TAKES THE STRAIN

HCS SERIES SNAP-ACTION SWITCHES WITH REINFORCED MOUNTING HOLES

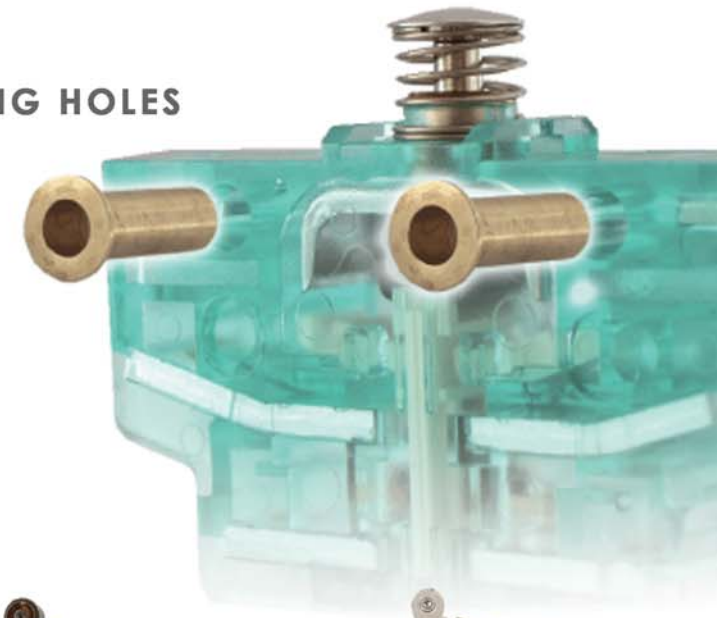
It's no fault of the standard switch but many of our clients have confided that they have great difficulty in avoiding over tightening of the switches during assembly.

However much they try, there will always be the opportunity for an assembler to over tighten the device, pinching the mechanism or damaging the plastic case.

Hertford Controls can now offer genuine Schaltbau switches S800, S826, S847, S820 and S850 with mounting holes strengthened by way of hollow brass inserts.

This takes the strain off the case and the assembler at the same time!

* It is important to note that the strengthened versions reduce the fixing bolt size from M4 to M3
